TECHNICAL MEMORANDUM

Date: March 17, 2022

Subject: AFRH-W Zone A CTR – DDOT Recommended Mitigation Response

Site Layout and Phasing Plan

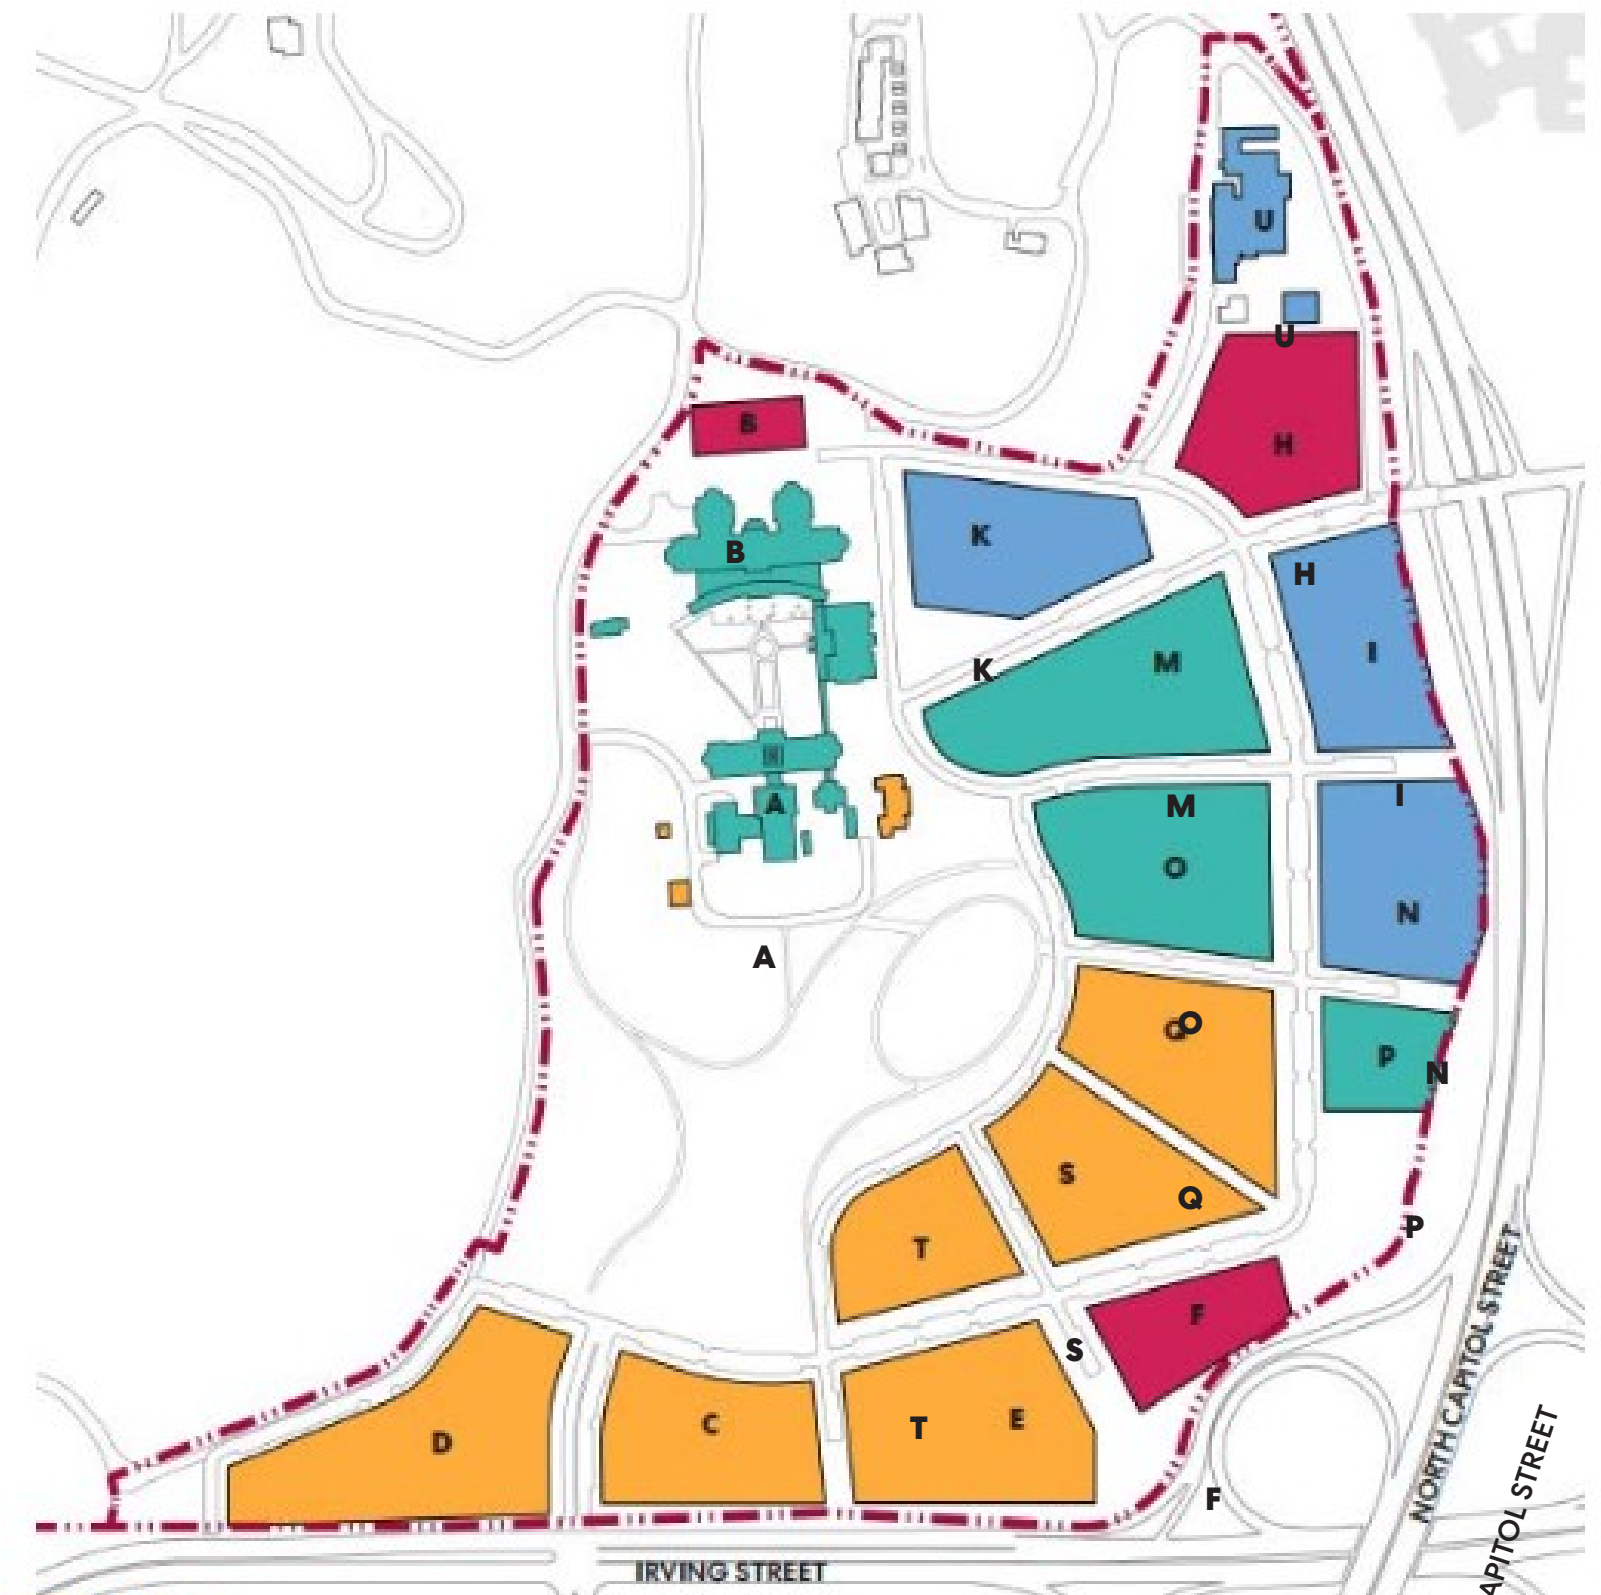
1. *Traffic Impacts – The CTR identified eight (8) intersections that are impacted by site-generated traffic from development of this site. Most of the remedies recommended in the CTR were to implement a Transportation Demand Management (TDM) program or re-time traffic signals. There were also specific recommendations about changing the operations of Allison Street and Buchanan Street north of the site. Instead of implementing these recommendations from the CTR, DDOT recommends the comprehensive multi-modal mitigations in the next section that will collectively go a long way in reducing vehicle trips through the impacted intersections.*

Response: Based on DDOT’s feedback, the proposed mitigation and TDM strategies have been revised as presented below in response to specific comments. The proposed mitigation outlined in this letter supersedes

the mitigation presented in the October 2021 CTR and will also include the multimodal measures listed below which are not specifically addressed in the comments that follow:

- **Irving Street and First Street NW Improvements:**
 - The extension of First Street NW northward from the Irving Street and First Street NW intersection to serve as the gateway access for the site with inbound and outbound access available between Parcel D and Parcel C.

Improvements to North Capitol St. / Hawaii Ave. NE / Allison St. NE

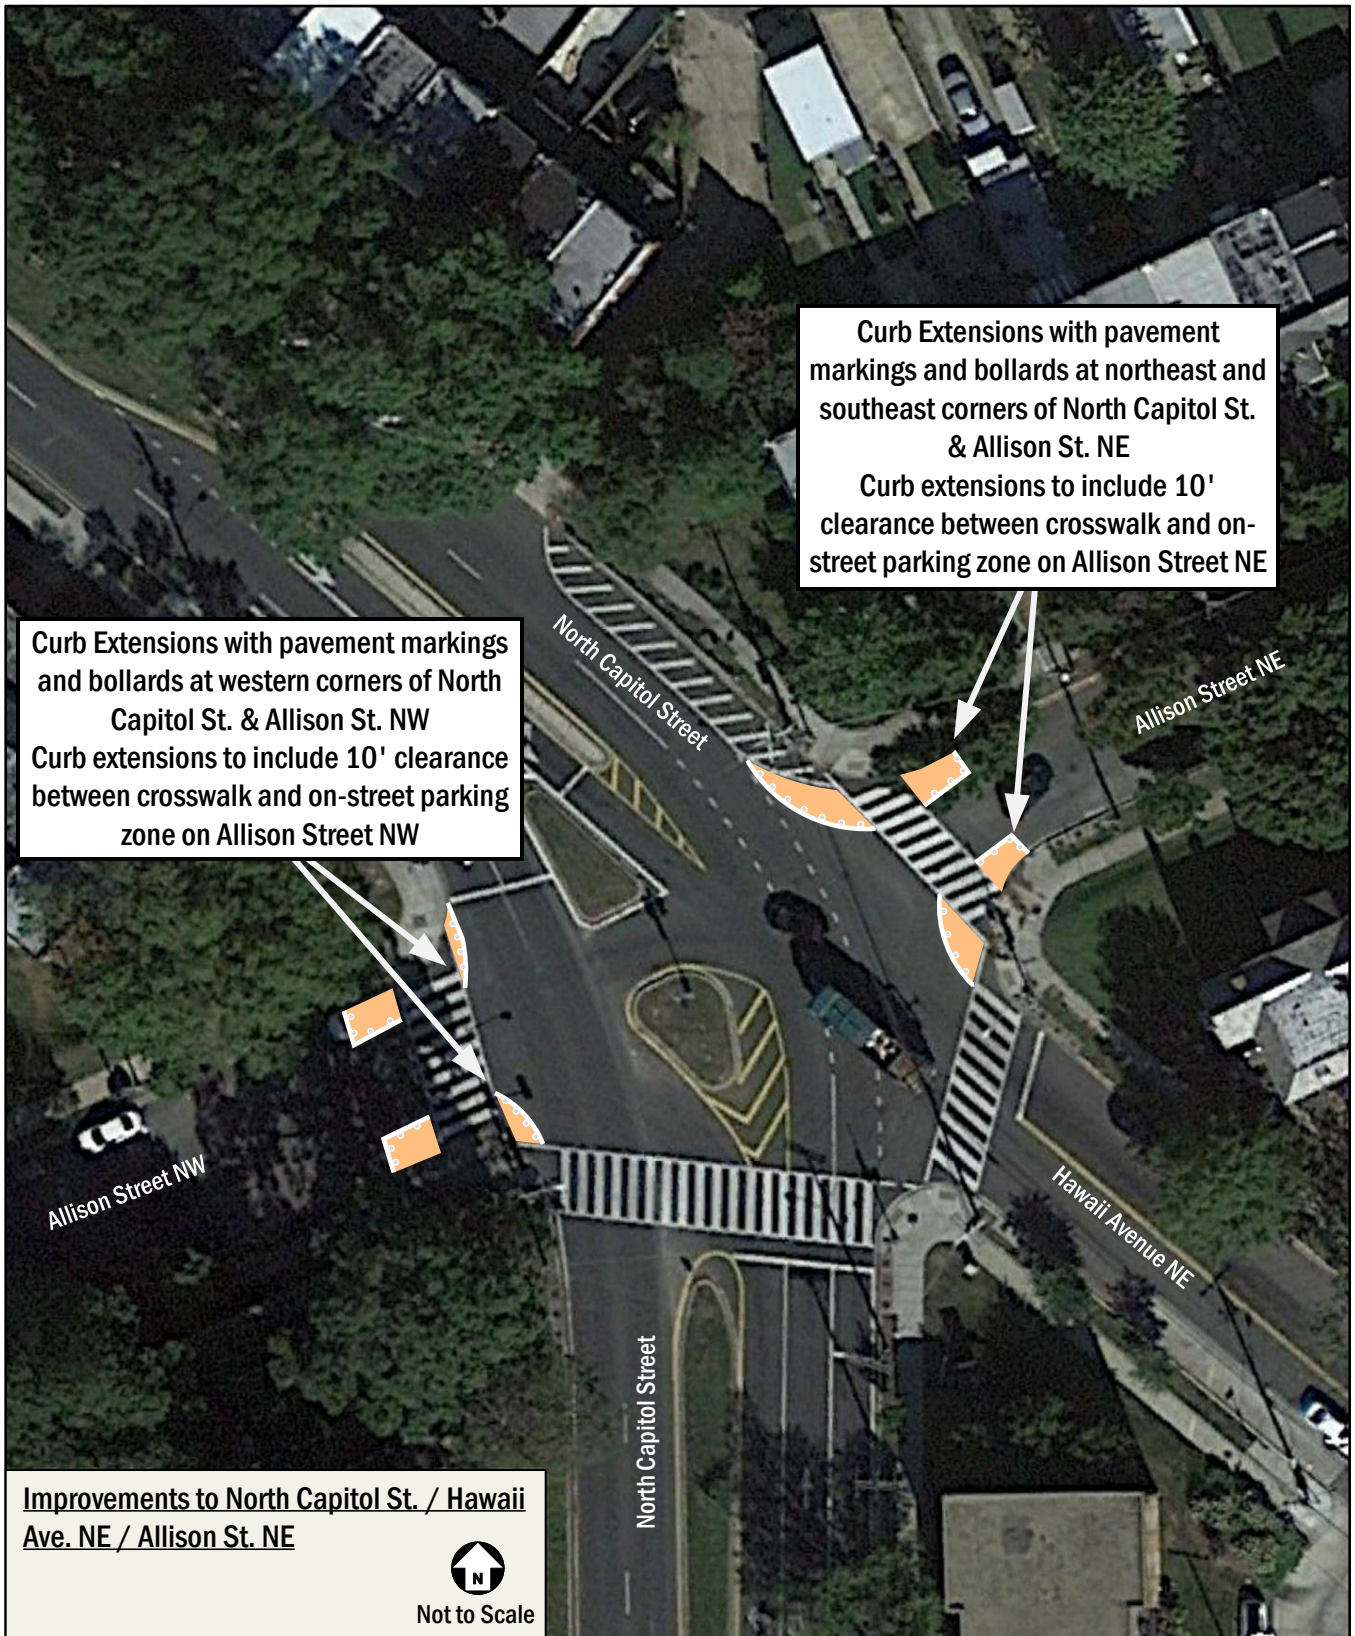
4. *Intersection of N. Capitol Street, Hawaii Avenue, Allison Street and Buchanan Street – The CTR identified impacts to this large combination of intersections and recommended changes to the directionality of Buchanan Street and potentially terminating Allison Street NE at the intersection. Since this intersection was most directly impacted by the AFRH project, DDOT requests the Applicant fund and lead the re-design and construction of this intersection. This may include closing slip lanes, closing off legs of the intersection, implementing turn restrictions, signal modifications, curb extensions, etc.*

Response: Based on DDOT's feedback the development team has identified the tactical improvements listed below at these intersections. Conceptual sketches of these improvements are also attached for your reference.

- **N. Capitol Street and Allison Street/Hawaii Avenue**
 - **Curb extensions w/ flex posts and white and tan pavement markings at the western corners of North Capitol St. & Allison St. NW**

- **Curb extension w/ flex posts and white and tan pavement markings at the northeast corner of North Capitol St. & Allison St. NE**
- **Large curb extension w/ flex posts and white and tan pavement markings at the southwest corner of North Capitol St. & Allison St. N**
- **Curb extensions to provide 10-foot clearance between crosswalks and parking zones on Allison Street.**
- **N. Capitol Street and Rock Creek Church Road/Buchanan Street**
 - **Stripe extension of existing painted curb lane buffer to north of Buchanan Street**
 - **Upgrade crosswalk across North Capitol Street to a high visibility crosswalk**

The developer proposes a maximum \$60,000 budget for completion of the tactical improvements as conceptually presented in the appendix. The \$60,000 will be contributed directly to DDOT's Mitigation Fund for DDOT's use for implementation of the improvements.

Curb Extensions with pavement markings and bollards at western corners of North Capitol St. & Allison St. NW
Curb extensions to include 10' clearance between crosswalk and on-street parking zone on Allison Street NW

Curb Extensions with pavement markings and bollards at northeast and southeast corners of North Capitol St. & Allison St. NE
Curb extensions to include 10' clearance between crosswalk and on-street parking zone on Allison Street NE

Stripe extension of existing painted buffer

Stripe extension of existing painted buffer

Upgrade crosswalk to high-visibility
